**ADDENDUM 1**  
**Sausalito Library Renovation Project**  
**420 Litho St.**  
**Sausalito, CA 94965**  
**August 23, 2012**

**THE FOLLOWING ITEMS REPRESENT Addendum NO. 1**

The purpose of this addendum to the current Bid package for the above-referenced project is to provide clarifications, additions, deletions, changes, and / or revisions to the package per the attached documents and sheets.

**2 ELEVATION**  
SCALE: 1/2" = 1' - 0"

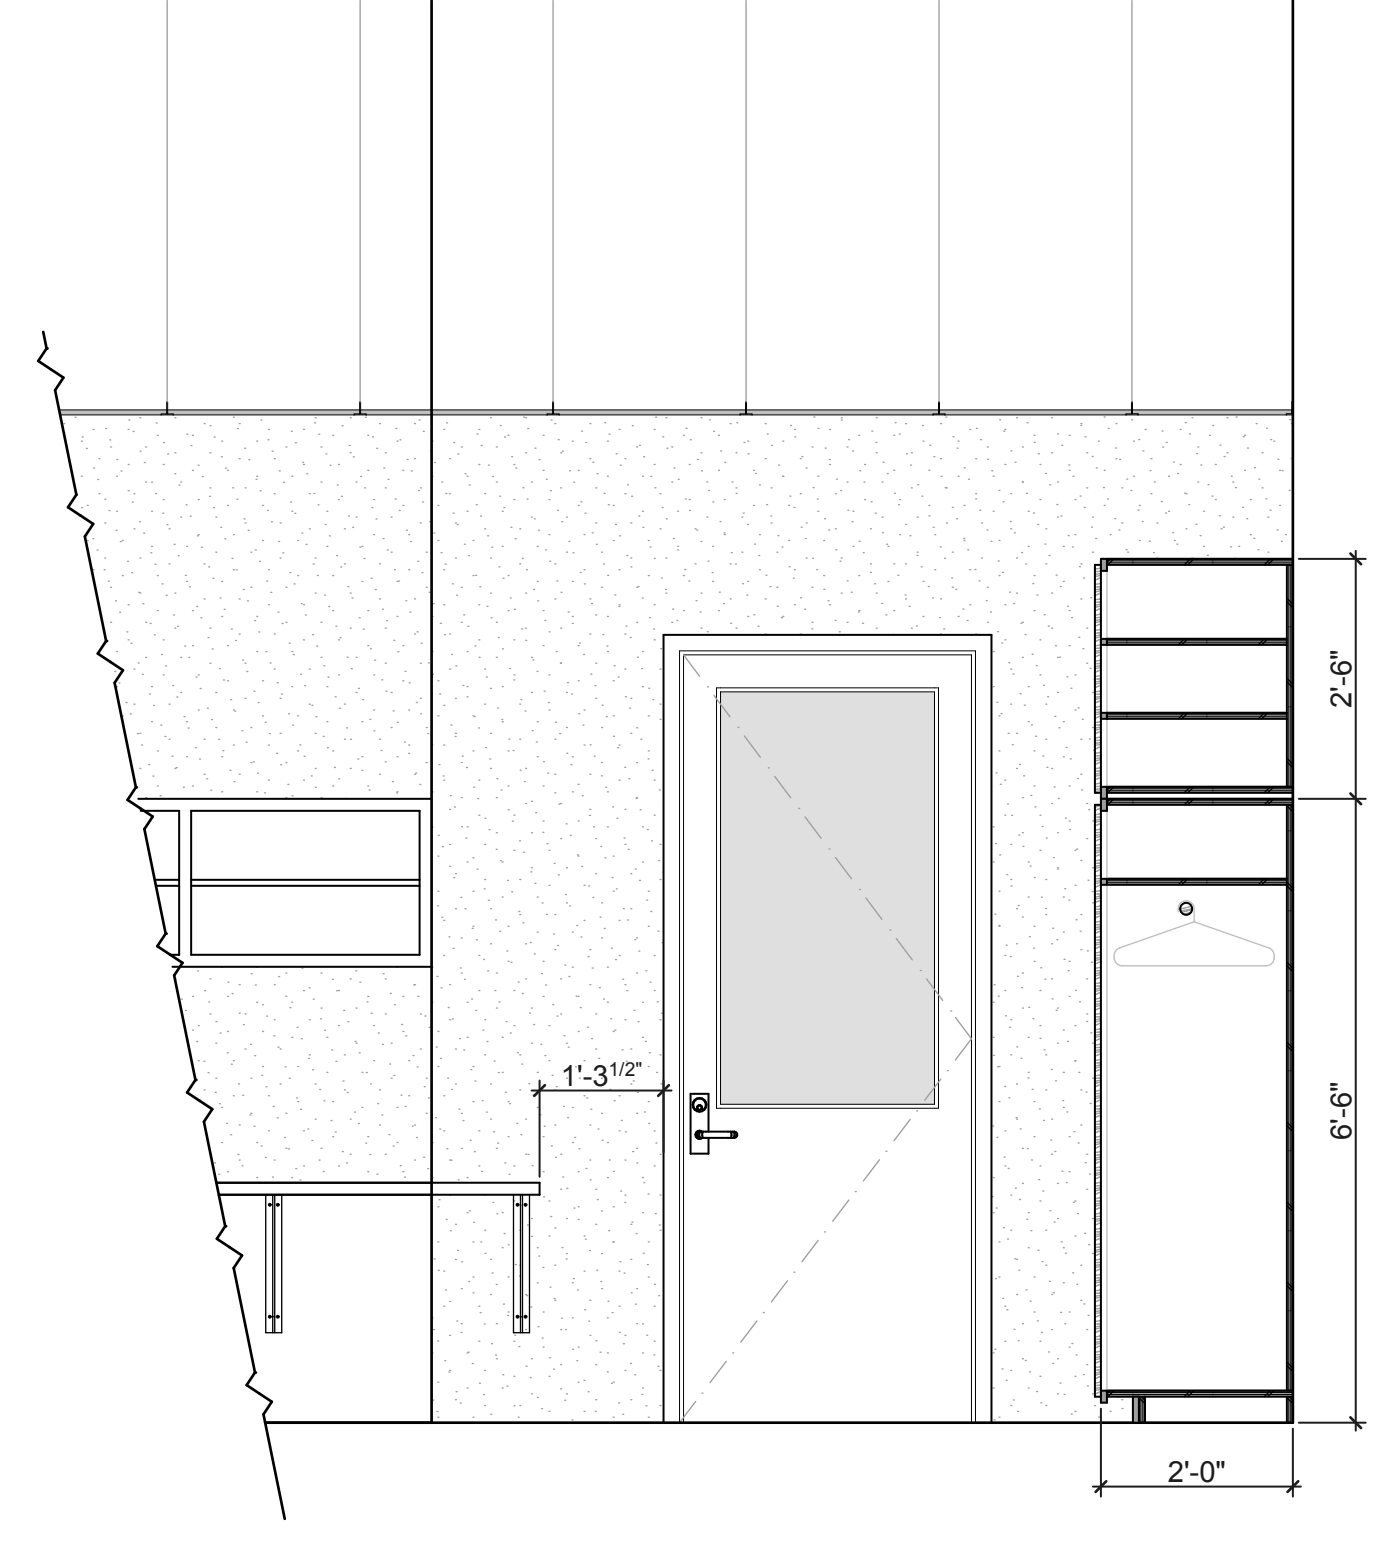
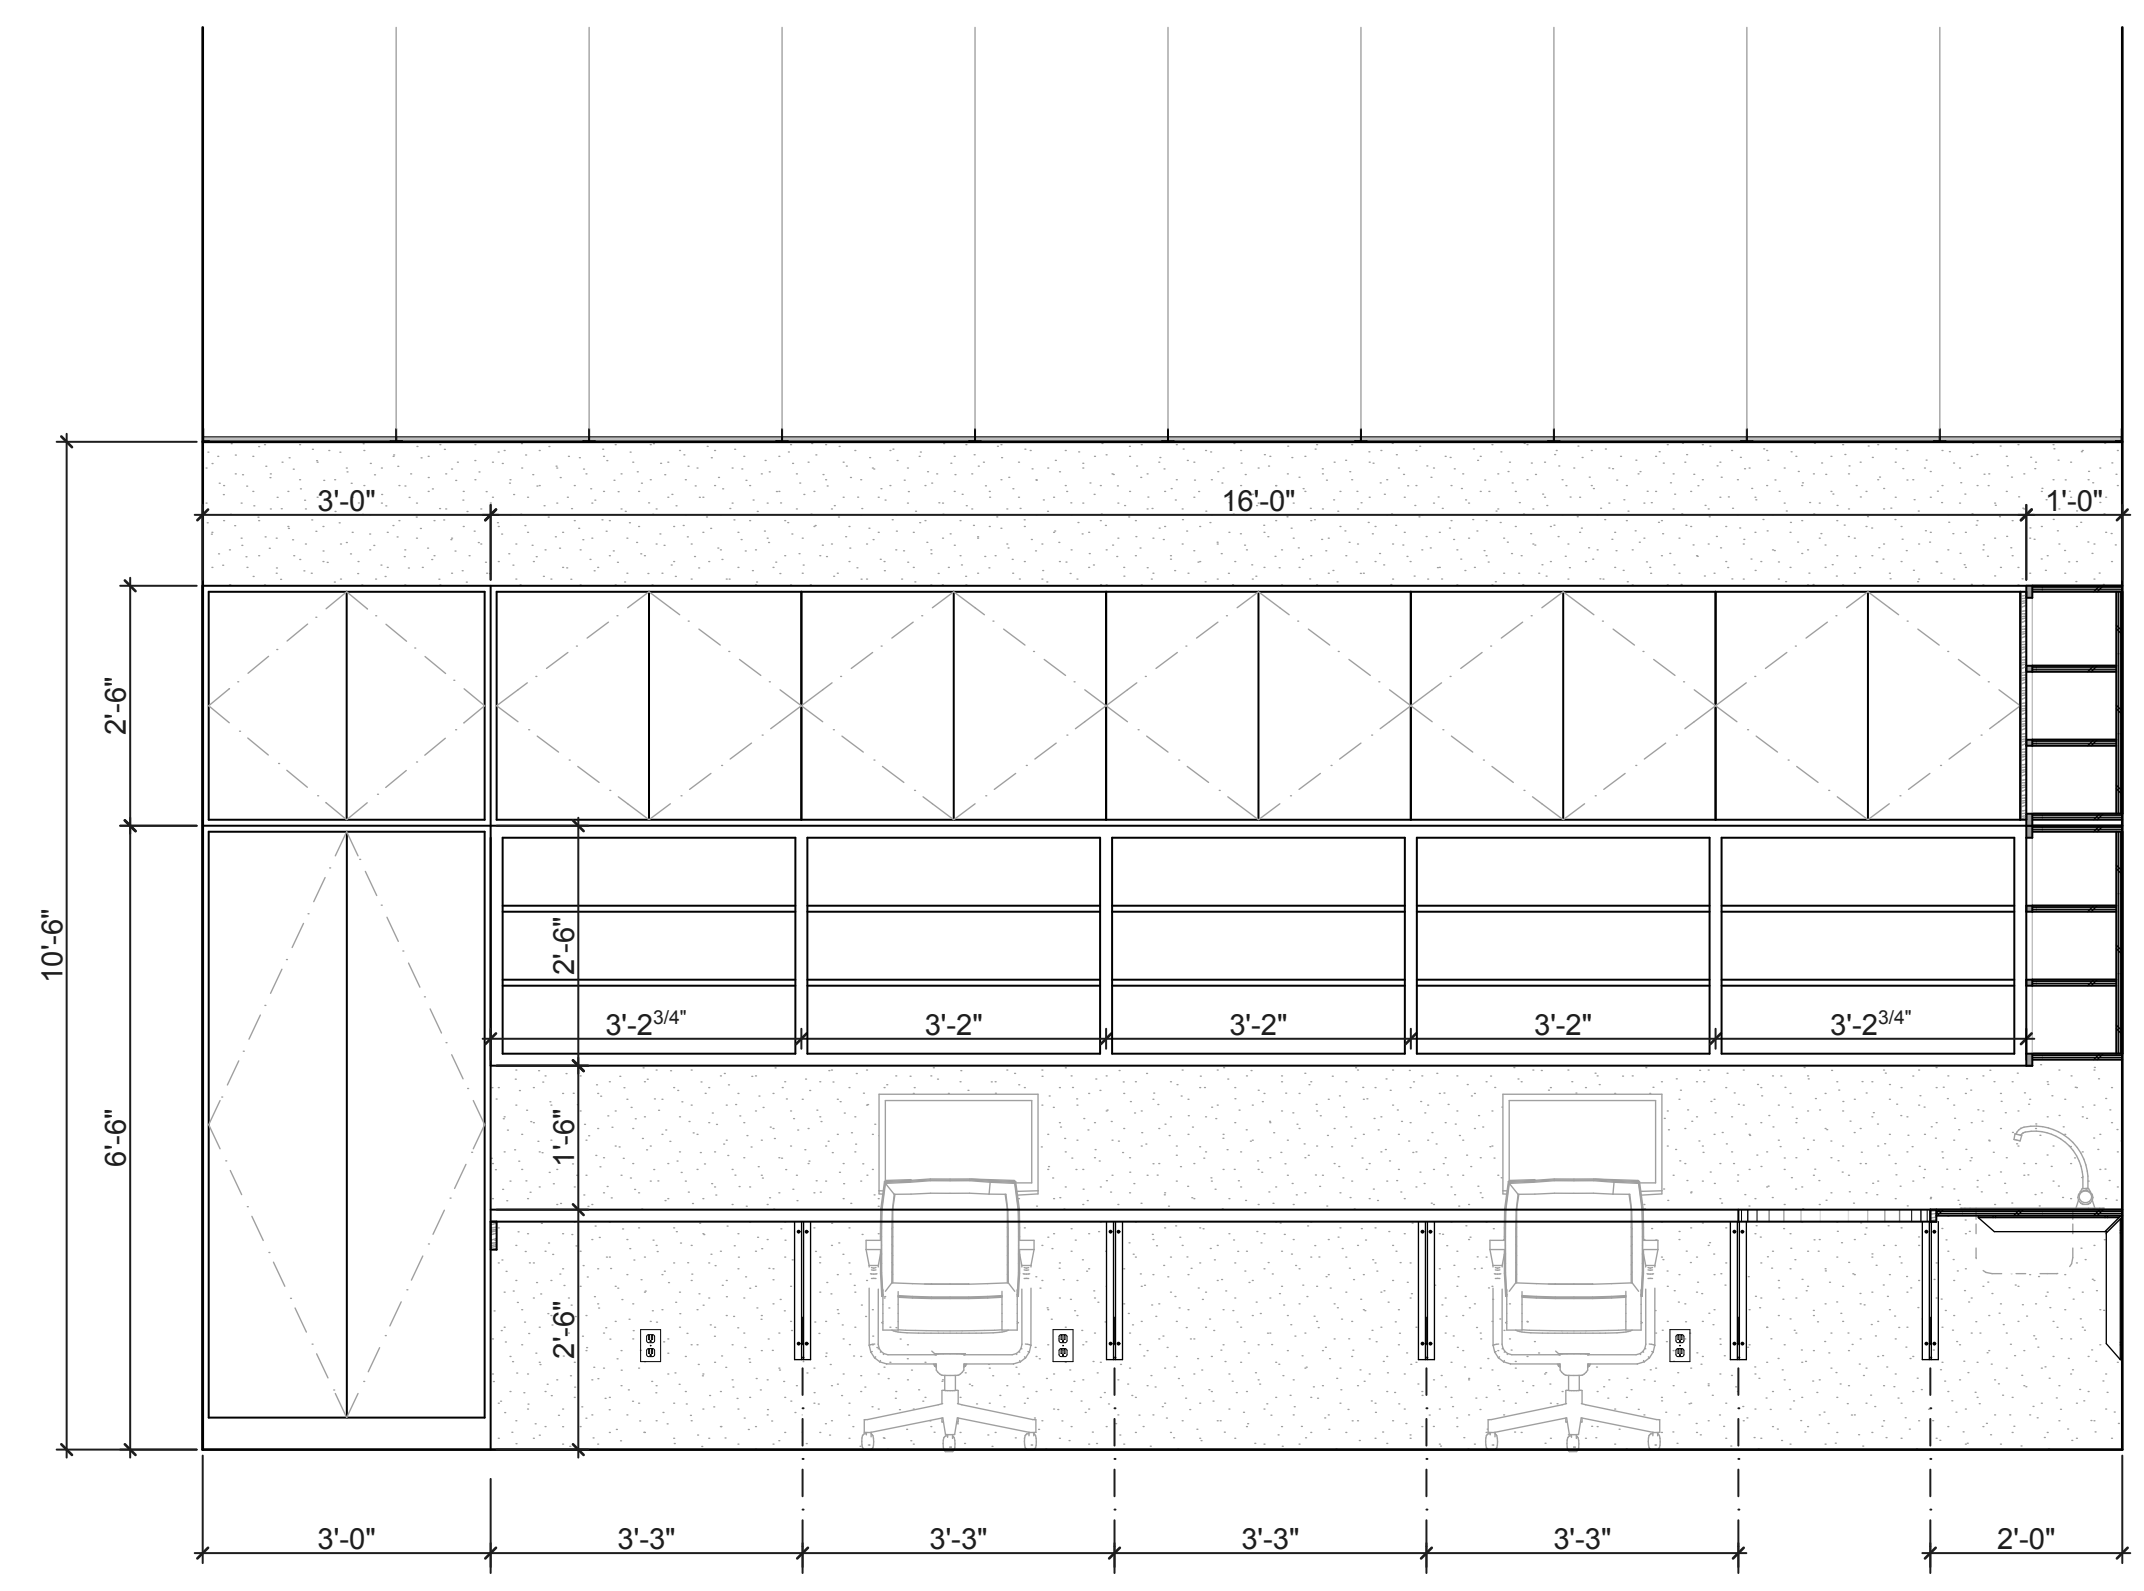
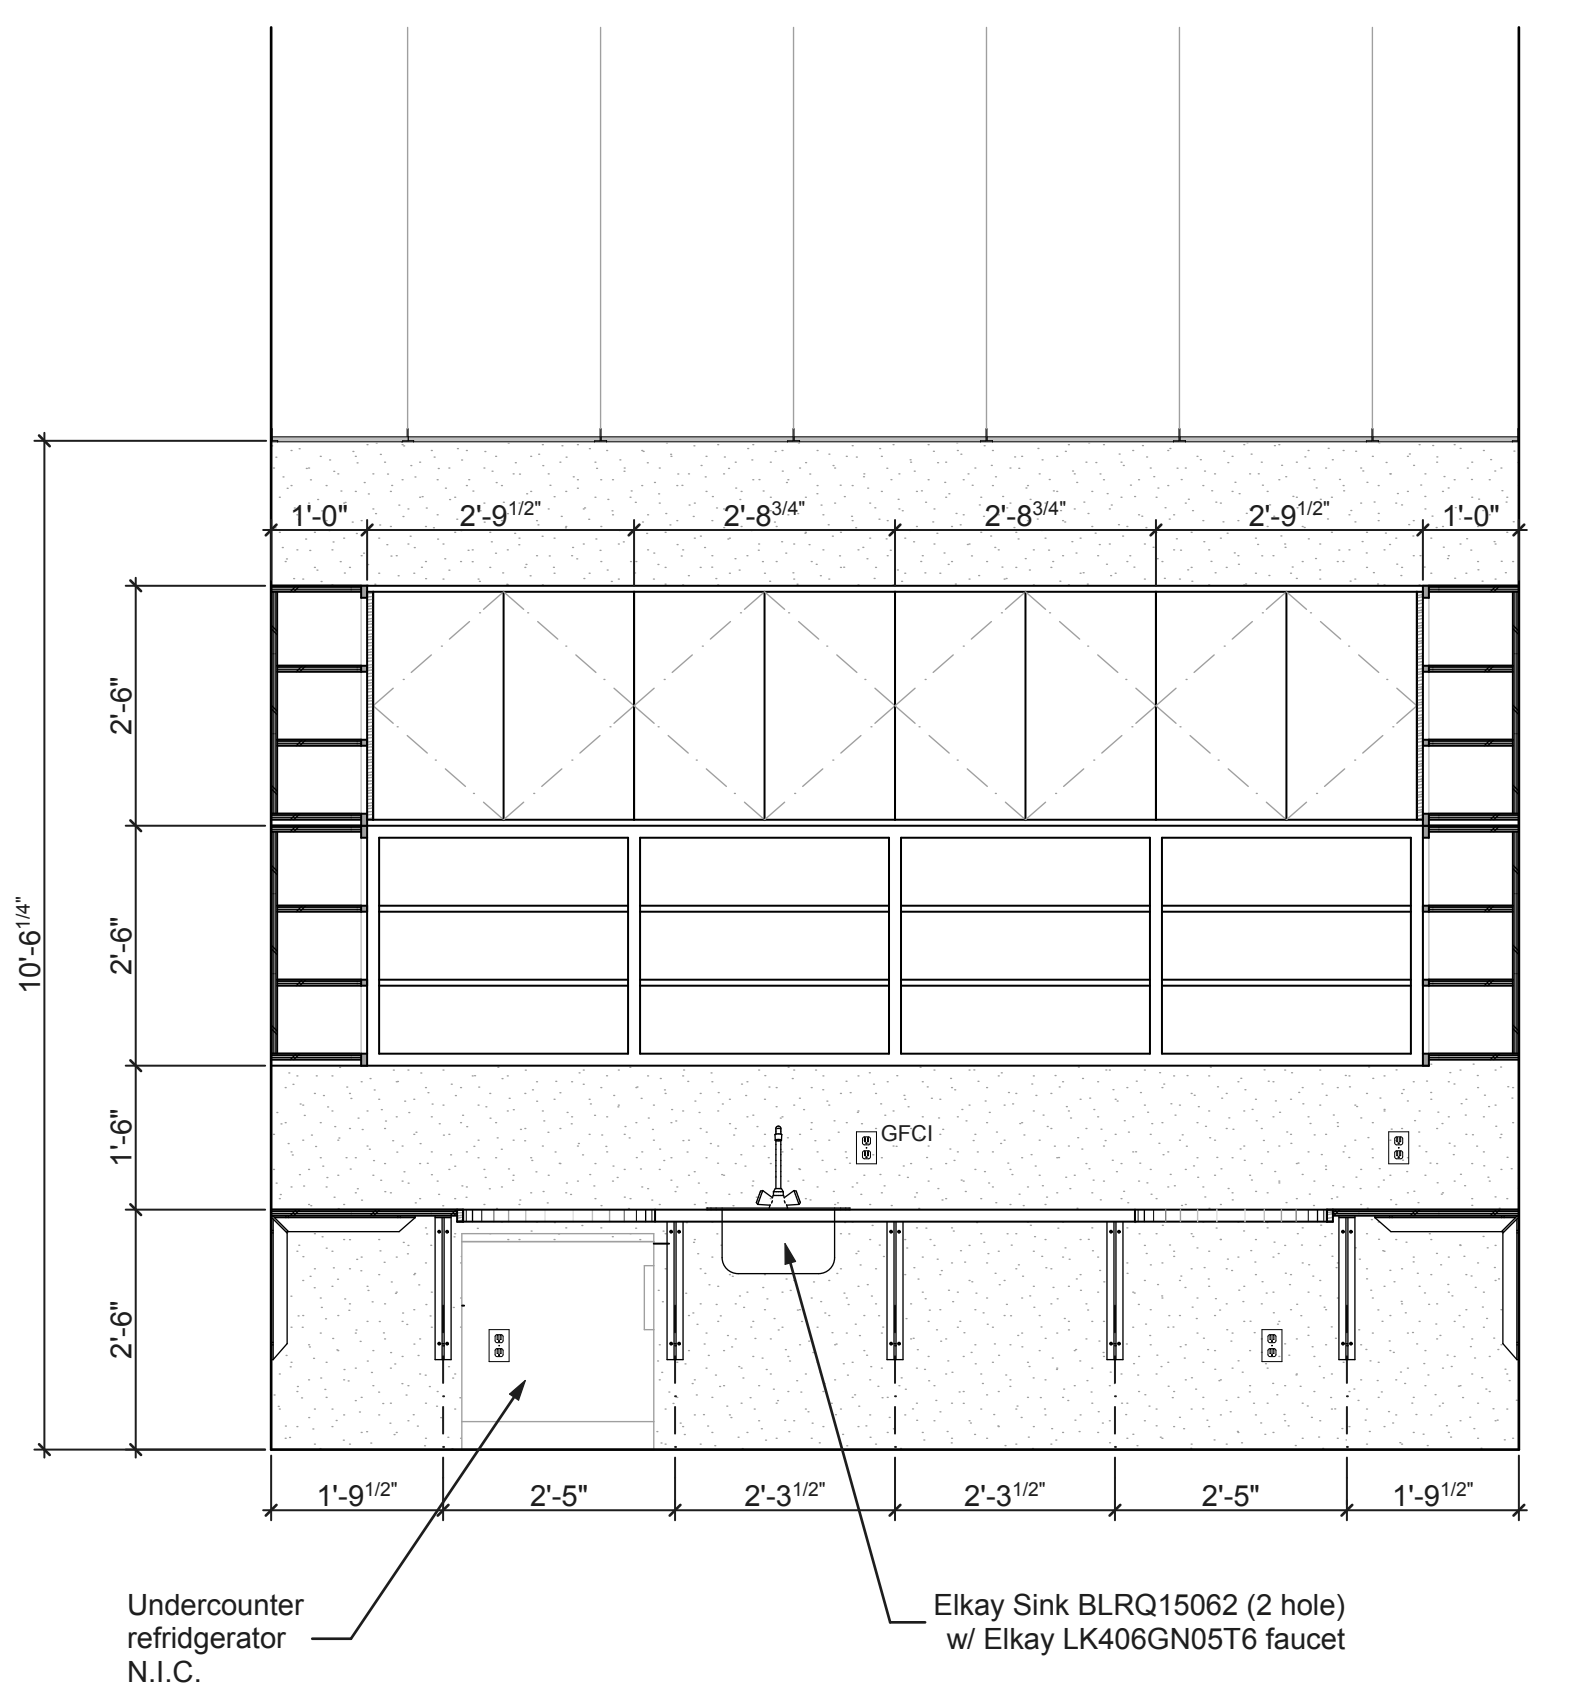
- 8) Sheet A3.1 – Change to Scope – Sheet A3.1 has been added to Contractors Scope of Work. Contractor shall include in Bid Price cost to install Casework in Staff Office.
